CABINET MEMBER FOR TRANSPORT - 24 MARCH 2011

OXFORD, HIGHFIELD AND OLD ROAD TRANSPORT IMPROVEMENTS

Report by Deputy Director of Environment & Economy – Highways & Transport

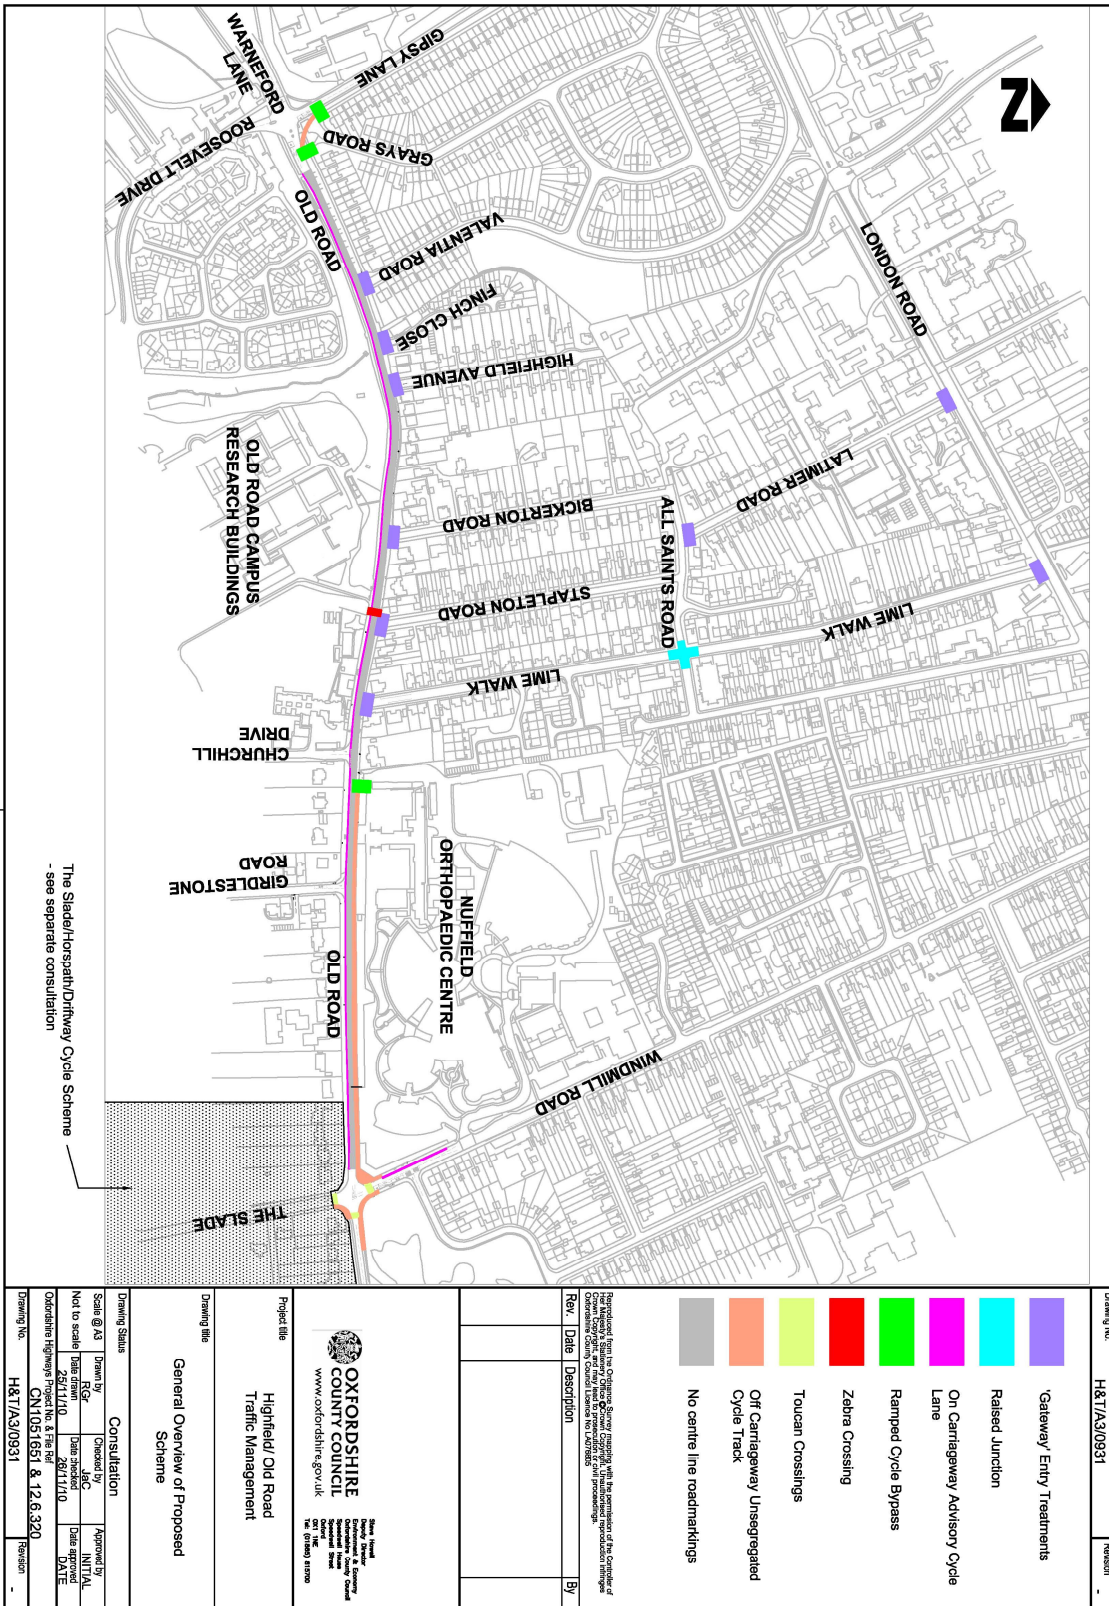
Response Ref	Question: Your comments:	Officer response
Stapleton Road	Dear Sir, Not sure if this is the right place to do this but I can't find anywhere else to put it. I have consulted with my neighbours and we would like to request that when Stapleton Road's CPZ is remarked we would like the Double Yellow lines between No's 52; 54 to be removed to allow a continuous parking bay. We also requested this action on the form that was sent out about 9 months ago, but when the road was marked up for change, the Yellow lines have been left in.	1. Passed to Parking Team
Latimer Rd	Dear Mr Green Thank you for your consultation letter dated 7 December. As a resident whose house is at the junction of Latimer Rd and All Saints Rd, I broadly welcome the overall plans put forward. The Gateway entry at the junction of Latimer and All Saints should reduce the speed of cars at this junction. However, the more pressing issue on Latimer Rd is that it is straight with most cars parked on the Lime Walk side of Latimer Rd. This encourages many drivers cutting through to drive at high (and dangerous) speeds along a straight stretch of road that has no obstacles to negotiate. Given a choice, I would rather trade off the Latimer Rd/All Saints Rd Gateway for some form of chicane part way up Latimer Rd that would block the straight line of sight up the road and cause vehicles to slow down when using the road.	2. The large majority of the reported accidents in the area occur at side road junctions and although there have not been any reported accidents in the past 5 years at the Latimer Road/All Saints Road junction neither have there been any accidents within the road. A number of accidents have been reported at the London Road end and given the financial constraints of the scheme it is deemed appropriate to retain a consistent approach to traffic calming i.e. at the junctions. There is also an advantage to pedestrians when crossing side roads.

Bickerton Rd	Sadly this traffic management scheme does not take account of the high traffic now experienced on Old Road to serve the Churchill site developments of the past years. Removing centreline roadmarkings on Old Road is likely to prove dangerous given the hill, cycle and bus useage along with commuter use. My other comment is that the Lime Walk / All Saints Rd raised junction would be better replaced by a zebra	3. The removal of the centreline in conjunction with the cycle lanes would help to slow traffic by narrowing the carriageway and increasing uncertainty when vehicles pass. Local Transport Note (LTN) 02/08 (p.27) suggests that removing the centreline can reduce speeds but speeds are reduced further when

<p>I'm opposed to the amended plans on the grounds that there is no traffic calming measures included for the Highfield area. Several additional features previously included on the consultation have been added which have will have little or no effect in reducing either the volume or the speed of traffic currently using our streets as nothing more than rat runs between Old Road & London Road. No requirement for pedestrian crossing on Old Road& Waste of funding which could be better spent on traffic calming measures. Entry Gateways likewise waste of funds if they don't incorporate further traffic calming measures in Highfield. Gateways likely to cause both pedestrian and vehicle accidents, due to right of way issues as witnessed daily in the London Road since completion of the works.</p>	<p>9. Traffic calming measures are proposed on all side roads in the Highfield Area, at the junction of Lime Walk and All Saints Road and at Latimer Road and All Saints Road. This would help to slow traffic at these points where accidents are more prevalent.</p> <p>10. The proposed zebra crossing on Old Road has been positioned from surveys which identified that most people wanted to cross between Stapleton Rd and Old Road Campus pedestrian and cycle entrance. A crossing point here would help to encourage more walking and cycling in the area which will reduce congestion and through traffic. It is also seen in the context of future</p>

3. Proposal for a zebra crossing west of Stapleton Road The proposal for a zebra crossing west of Stapleton Road to help pedestrian reach the Old Road campus and Churchill Hospital is welcomed.

4. Raised gateway entry treatments (various locations) The proposals for gateway entry treatments on all side roads in Old Road (apart from Girdlestone Walk) and on Lime Walk, Latimer Road are also welcomed. This form of gateway has been shown to be effective in raising driver awareness that they are entering an area of different character, which is entirely consistent and appropriate to improving pedestrian and cycling facilities in this area.

6. On carriageway advisory cycle lane on Old Road As part of my review of the route on a cycle, I rode the route in both directions. I welcome the proposed 1.2m advisory cycle lane in a westbound direction. The area of concern on the route is the NOC entrance on Old Road which has been highlighted above.

21. On the basis of the consultation response, and the contribution the scheme would make to the county council's transport objectives and strategy, officers consider that no changes are required to the formal consultation scheme proposals.

22. **The Cabinet Member for Transport is RECOMMENDED to:**
- (a) approve implementation of the Highfield and Old Road Transport Improvements as shown on Drawing No H&T/A3/0931 as set out in Annex 3 to this report; and**
 - (b) authorise that the lengths of footway highlighted in orange in Annex 2 to this report be removed under the powers in Section 66(4) of the Highways Act 1980 and a cycle track constructed under Section 65(1).**
 - (c) authorize the Deputy Director of Environment & Economy – Highways & Transport, in consultation with the Cabinet Member for Transport, to make a final decision on the scheme elements to be removed from the design in the event that the costs need to be reduced to match the available funding resource.**
